Subject: ITB #2455-B: Starrs Mill School Tunnel Construction
Addendum #1

STARRS MILL SCHOOL TUNNEL

FAYETTE COUNTY	
STARRS MILL SCHOOL TUNNEL	
GRADING PLAN	DRAWING NO. 18-02

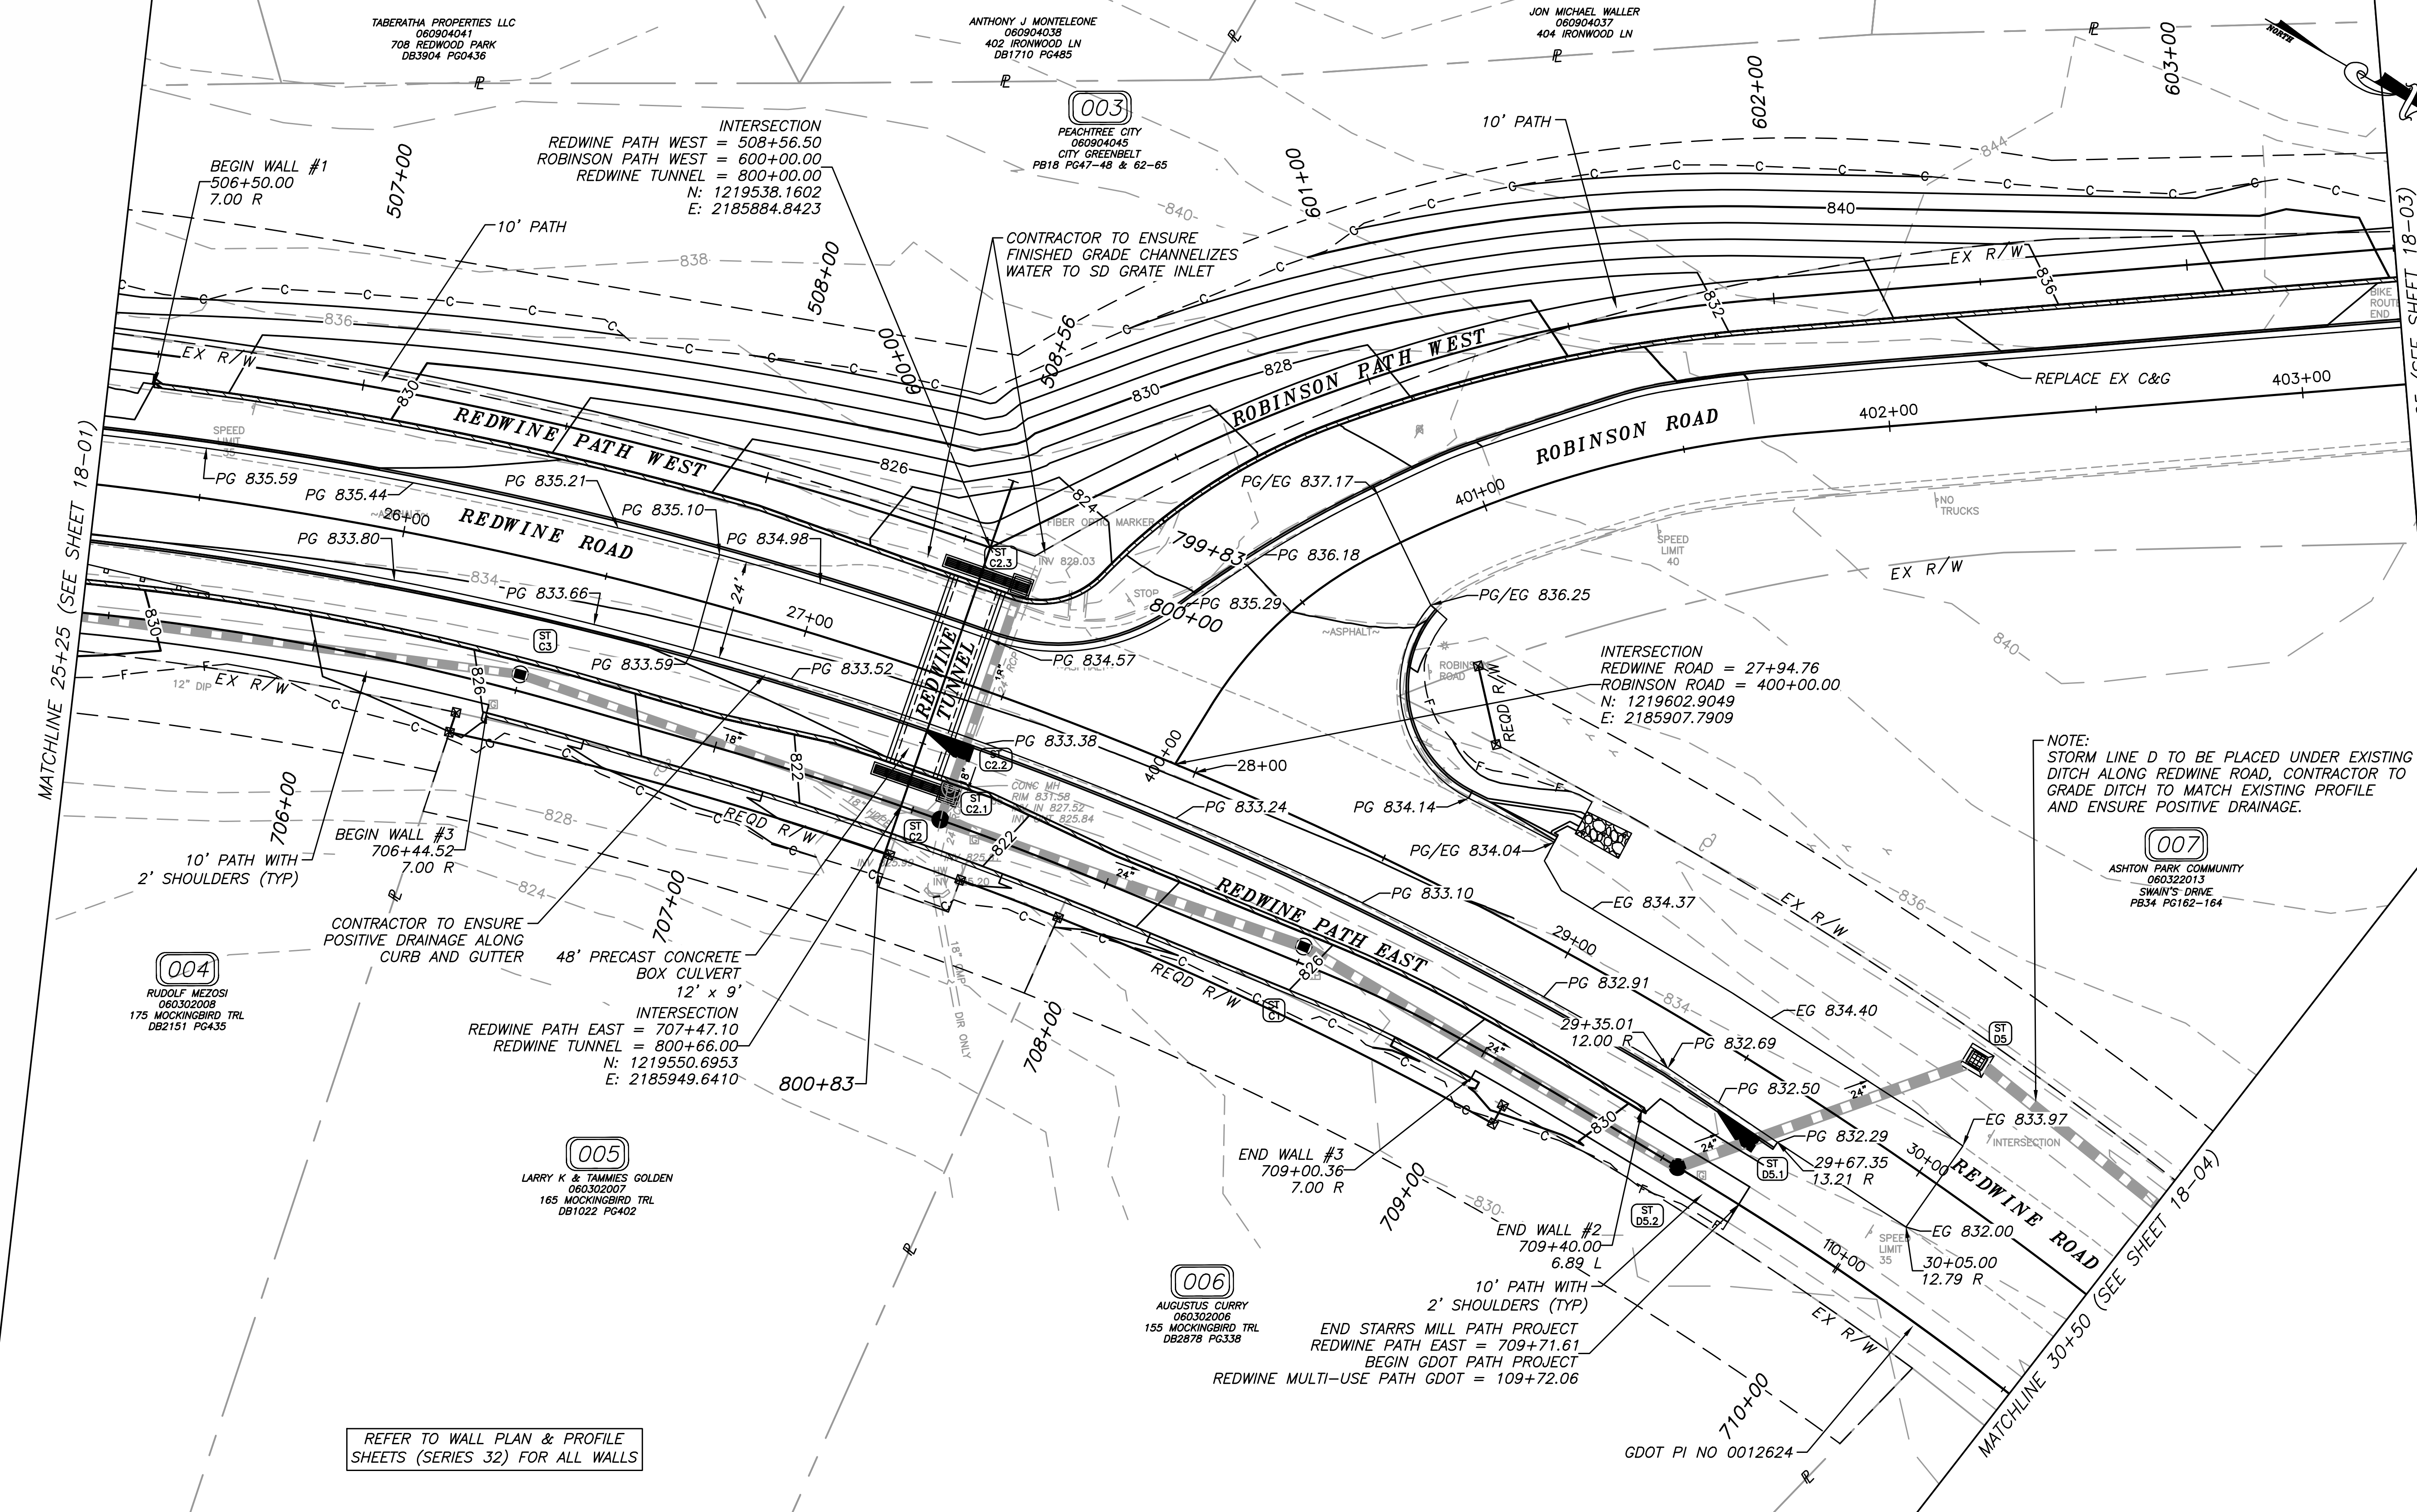
1. Please find question concerning drainage at Wall 3. The plans indicate removing the headwall & capping off the existing drainage pipeline (Drawing 13-02) at Station 27+50 +/- O/S 50 RT. This existing pipe has an invert of 825.20 and is draining the low spot away from the site (inlet headwall). Wall 3 profile show maintaining this low spot, but the plans do not address draining this low spot? Should we assume that we will end up utilizing the existing pipe for drainage thus having to remove and replace or add a drainage structure and pipe accordingly to drain into ST C2?

No additional drainage structures are expected. The existing topography typically falls away from the proposed Cut line shown in this area, creating a slight ridge. It is anticipated that the final backslope will cover the capped existing pipe. In the smaller localized area of the existing headwall, the contractor shall ensure final grading will provide a constant slope from the ridge line to the approximate back of wall. In addition, an updated Grading Plan to replace plan sheet 18-02 is attached as part of this addendum (Attachment 1).
